**SOLICITATION AMENDMENT
MODIFICATION DE L'INVITATION**

| Title - Sujet Furniture for NRC | |
| Solicitation No. - N° de l'invitation 31184-210469/A | Amendment No. - N° modif. 003 |

This amendment 003 is raised to respond to questions received from the Industry, publish revisions to solicitation documents, and extend the solicitation closing date to March 25, 2021.

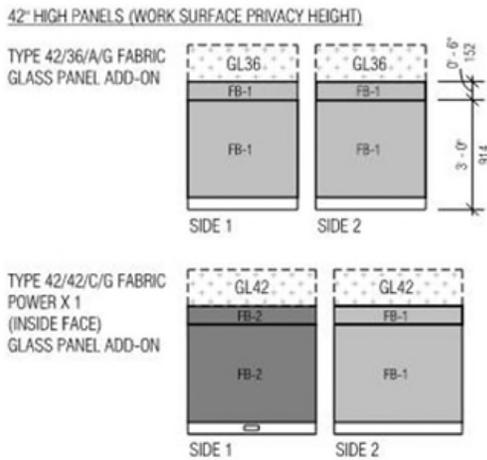
CAT1B Item 19, GoCUID is for 24"W but the description is for 36"W, please confirm.

Item should be 36"W, revise to GoCUID: 1BCPSXXNXXL36XCLNNN. Revise to GL36 per matrix provided in response to Question 3 below. Refer to revised drawings and Table 1 issued as part of this amendment.

| GL36 | 36w x 12h Glass Panel Add-On | Panel mounted privacy screen add-on, framless, clear glazing | (line 645) 1bCPSXXNXXL36XCLNNN | 20 |
| GL42 | 42w x 12h Glass Panel Add-On | Panel mounted privacy screen add-on, framless, clear glazing | (line 648) 1bCPSXXNXXL42XCLNNN | 12 |

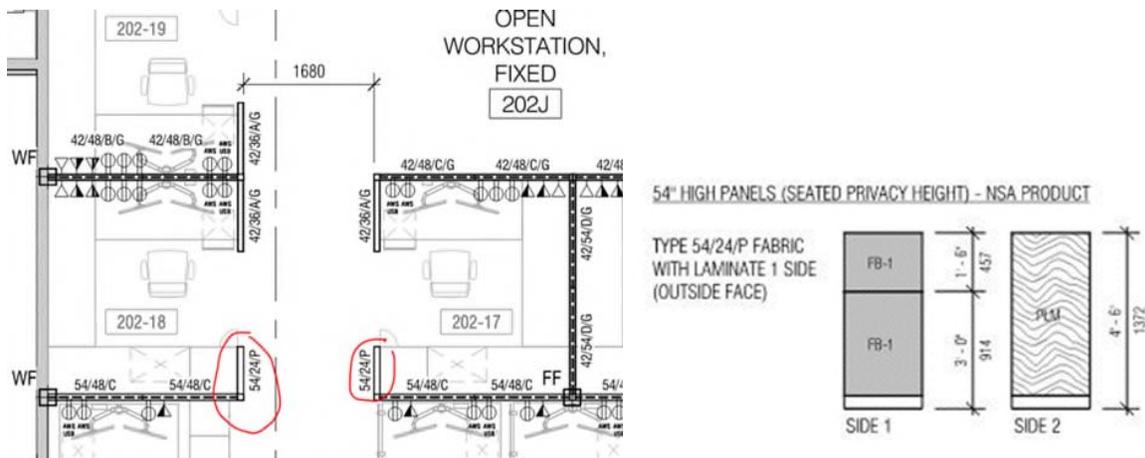
CAT1A NSA Line item 28, due to the panel builder configurations and stack-on modules it is not possible to have non-segmented tiles on one side only. Will the CA accept either a segmented laminate on the outside face or non-segmented fabric inside?

Non-segmented fabric inside is acceptable. Outside face must remain non-segmented laminate. Refer to images below for clarification. Refer to revised drawings and Table 1 issued as part of this amendment.

TYPE 36/53/D FABRIC
PASS THROUGH POWER

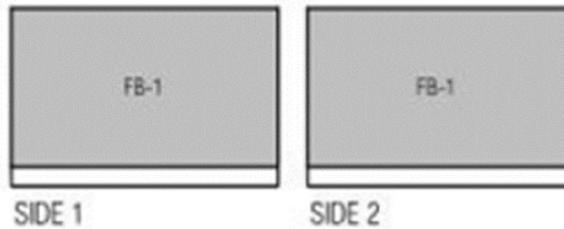
What exactly is meant by "pass through fabric"? Attached a snippet from the panel matrix where it asks for a "fabric pass through power". We would like a more detailed description on the pass through, is it for the fabric or for the power?

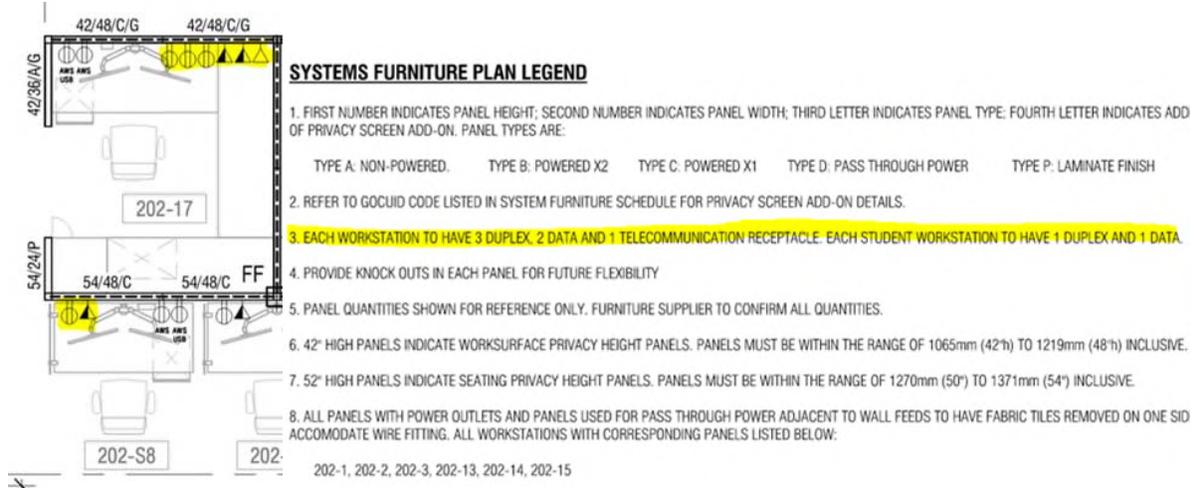
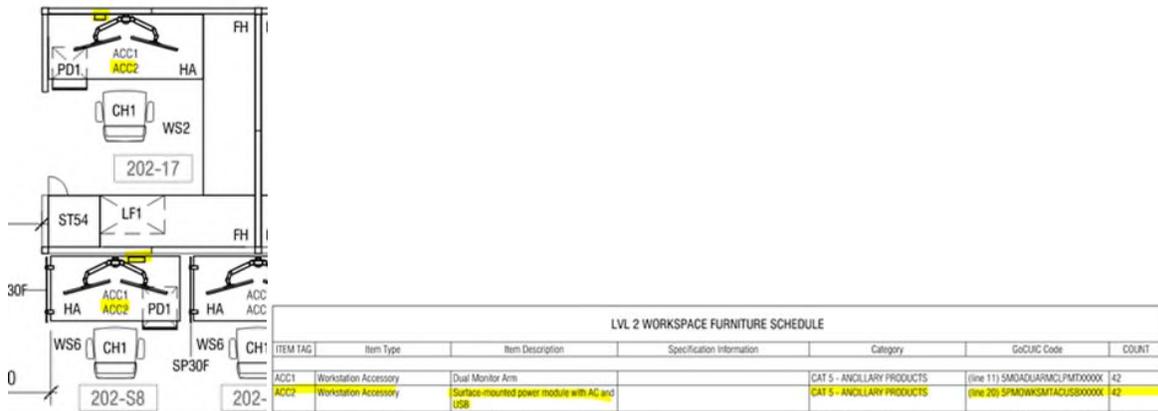
Electrical in panels - there is a discrepancy in number of receptacles required on plan vs. written descriptions. They are: Workstations: plan shows symbols for 5 duplex receptacles, but the written description is for 3 duplex per workstation.

Student desks: plan shows symbols for 3 duplex receptacles, written description is for 1 duplex per desk

Please confirm the number of receptacles required. For your reference the SA specifications require:

Workstations are to be provided with 3 duplex power outlets and 1 face mounted voice/data outlet that consists of: VOIP, GREEN (Data), ORANGE (Data). See below for further clarification.

In the images above, highlighted yellow are the power/data/voice provided from the panels. The 2 additional power symbols that are not highlighted come from ACC2, a workstation accessory (a surface-mounted power module with AC and USB). Note this is indicated in furniture plans (see plan and furniture schedule below for reference). Refer to revised drawings and Table 1 issued as part of this amendment.

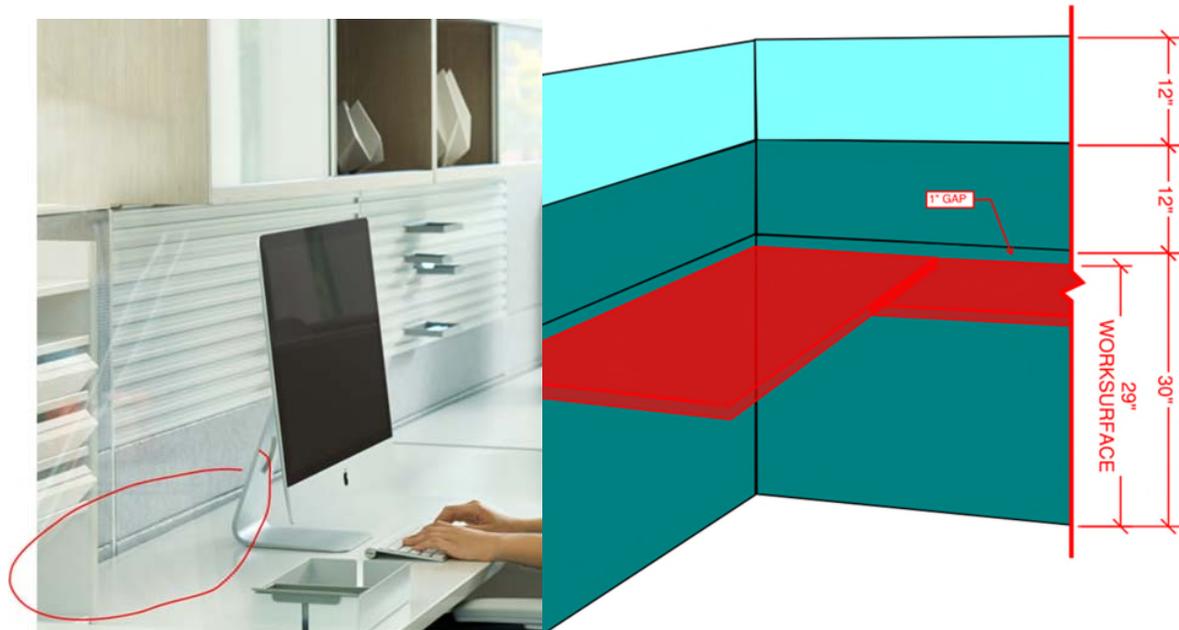
For the panel matrix, section FB-1 is requested at 6". Can the 6" be replaced with a 12" as long as we respect the overall height?

Changing 6" segment to 12" is acceptable. There is no conflict with horizontal rail height and panel-mounted work surfaces because panel-mounted work surfaces are hung on vertical railing, not horizontal. See below image for reference.
